7ABC BAYHAM STREET CAMDEN LIFESTYLE

SECTION 73 PROPOSED SCHEME AMENDMENTS
PLANNING APPLICATION
NOVEMBER 2020

This document has been prepared to present the amendments to the consented scheme (Ref: 2018/3647/P) which are predominantly internal and designed to suit the hotel brand.

THIRD FLOOR

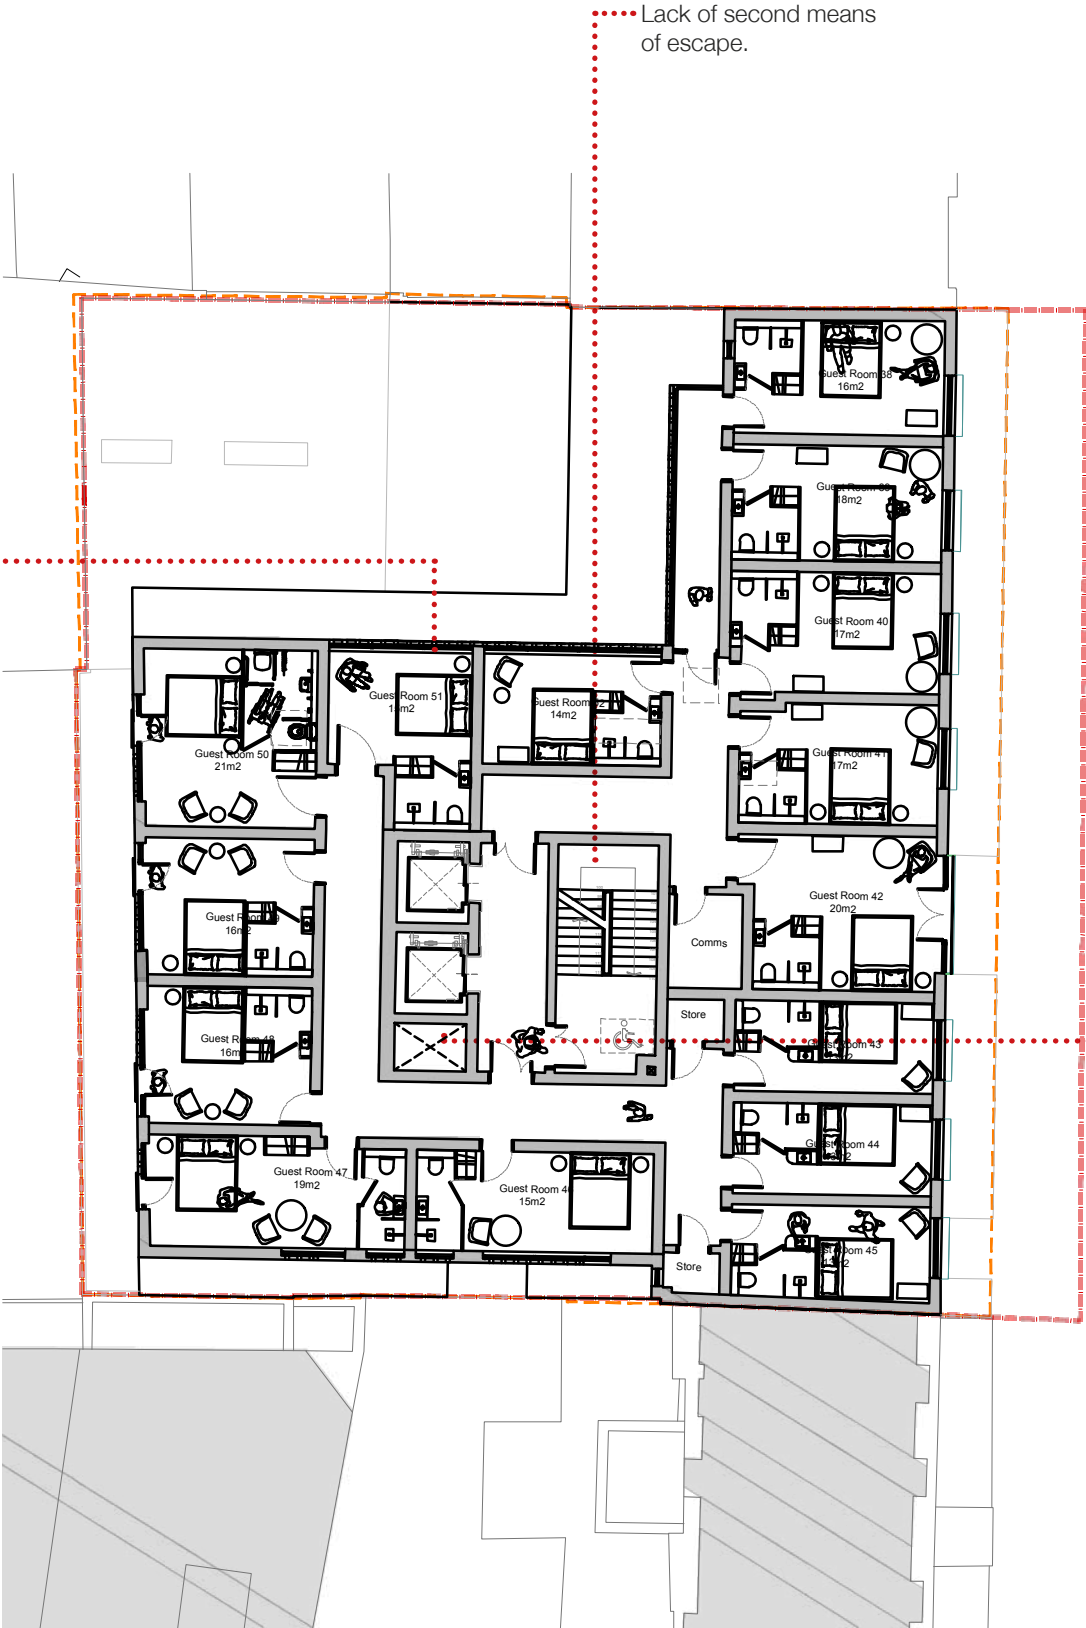
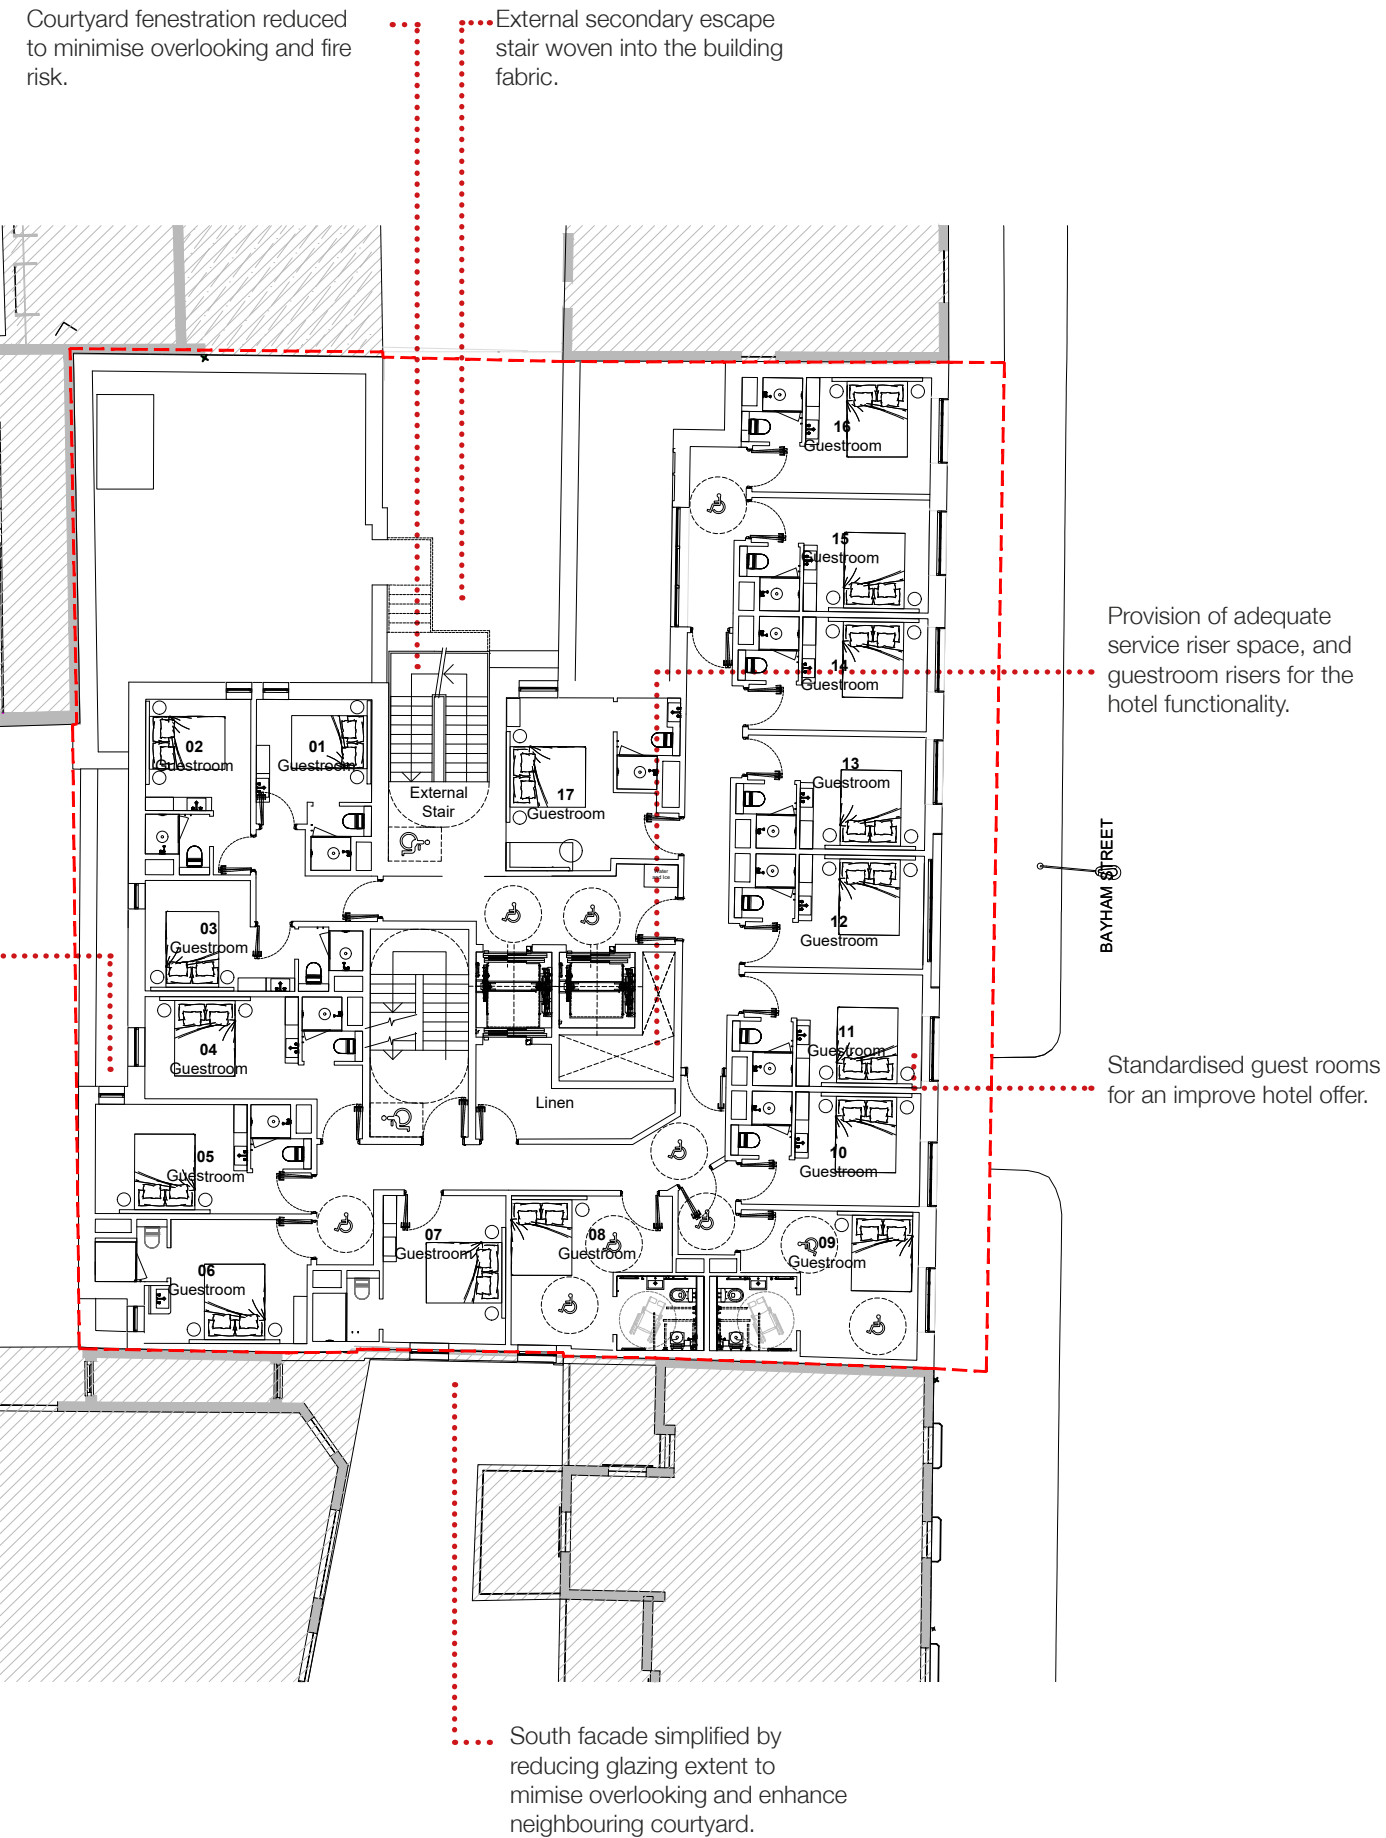
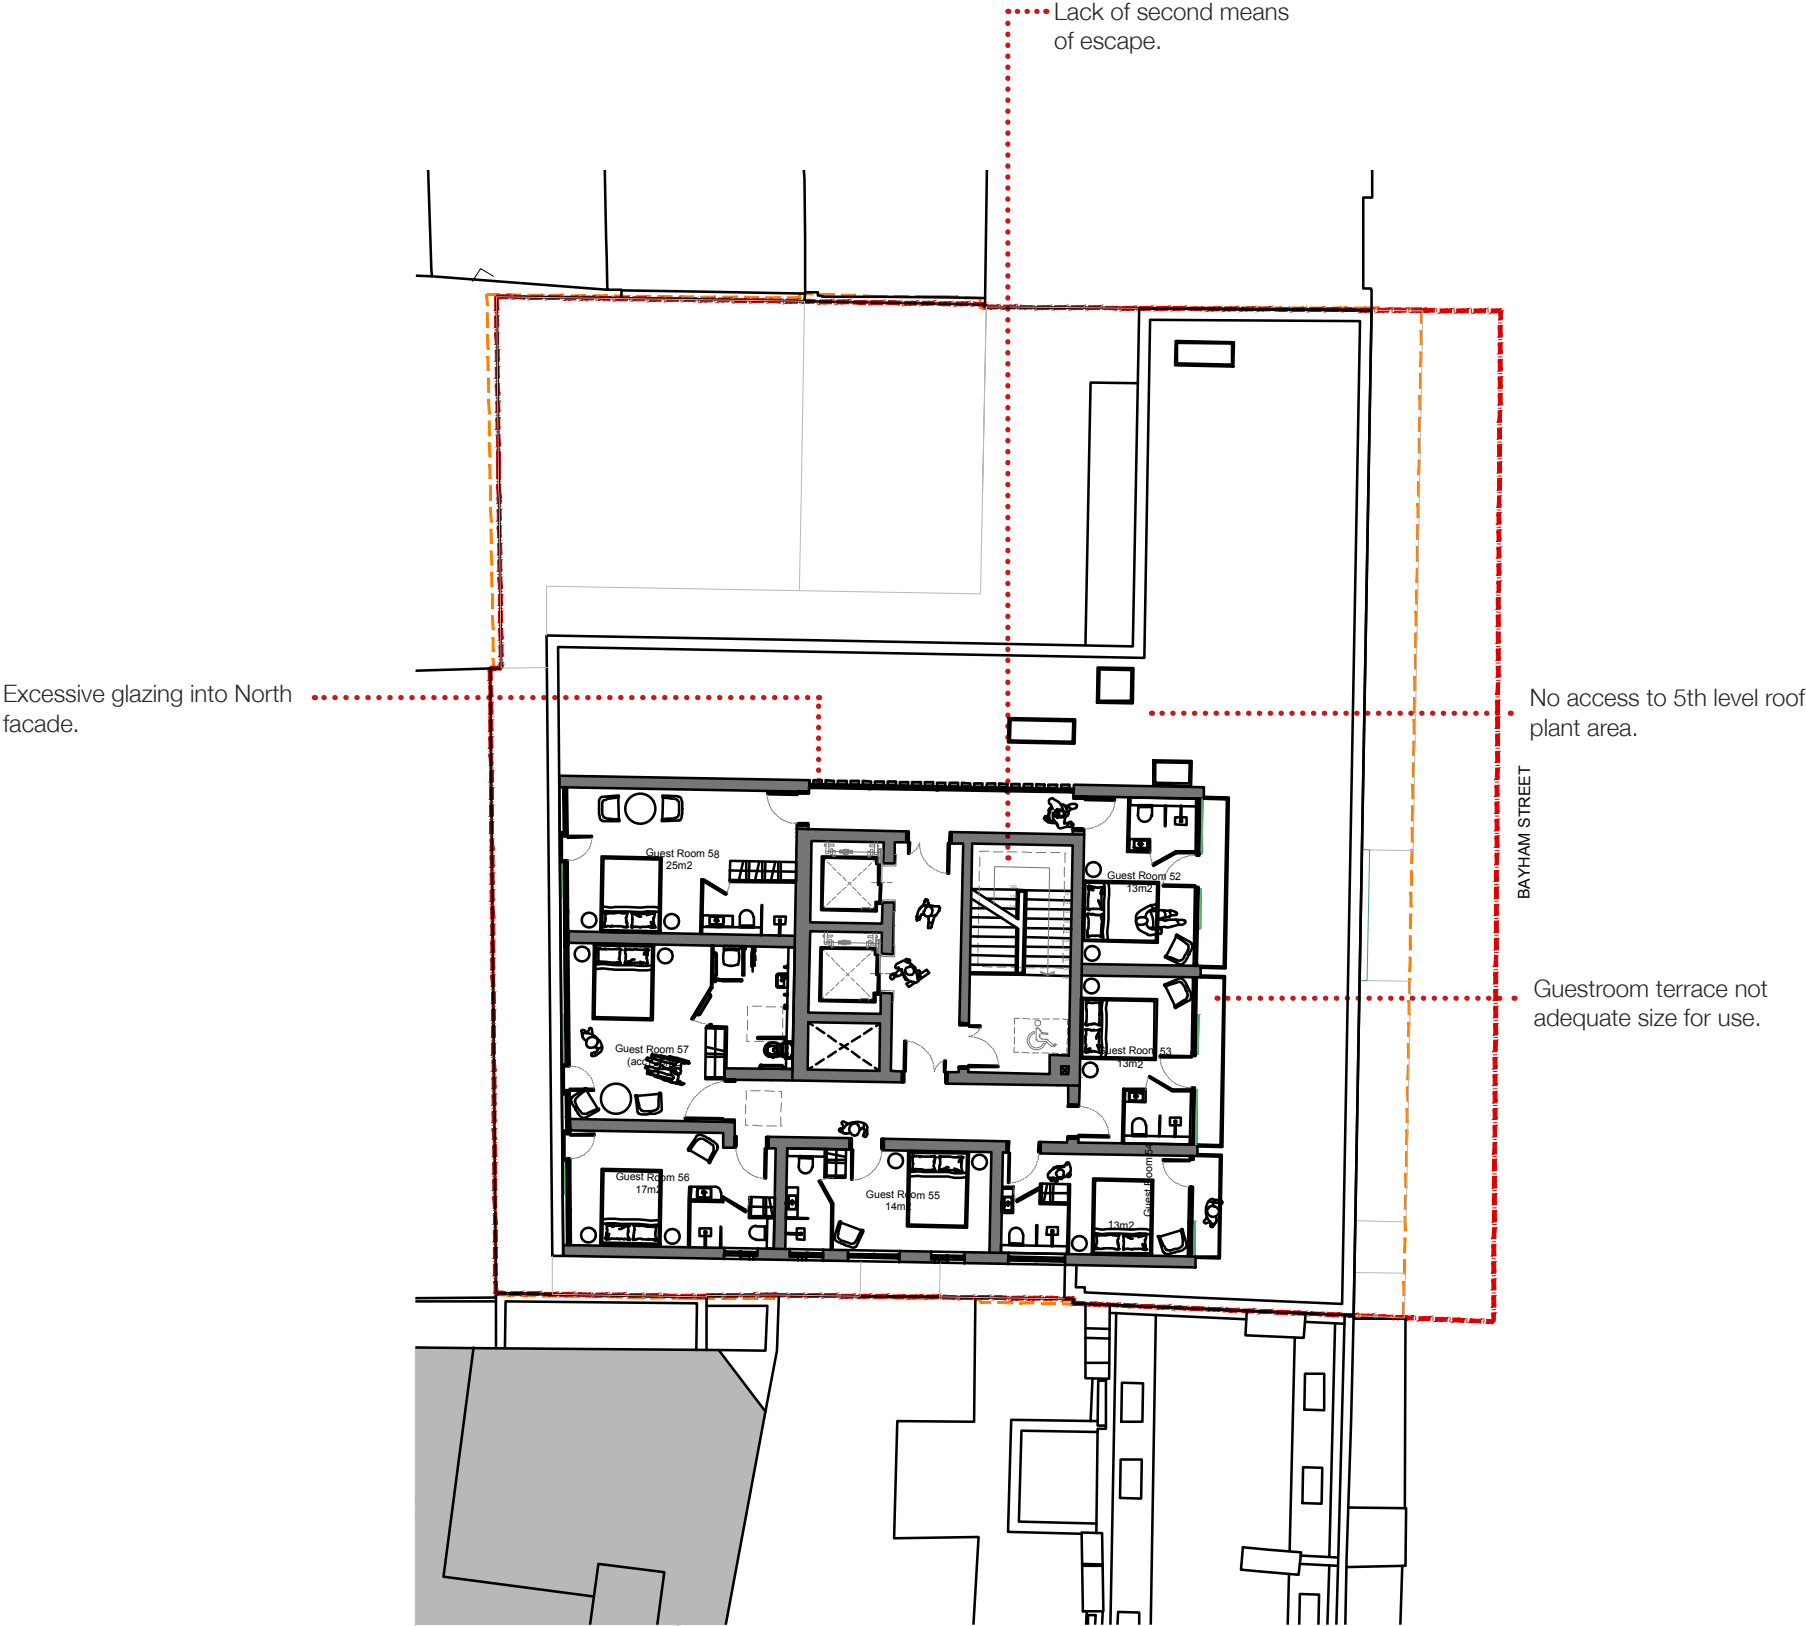
Excessive glazing to the north elevation, creating overlooking issues and difficult maintenance.

Lack of second means of escape.

Lack of services riser space in core and also within guestroom spaces.

- Guestroom configurations revised to improve the general circulation with the scheme.
- Guestroom layouts standardised to align with brand requirements.
- Linen stores introduced to each level with direct lift access.
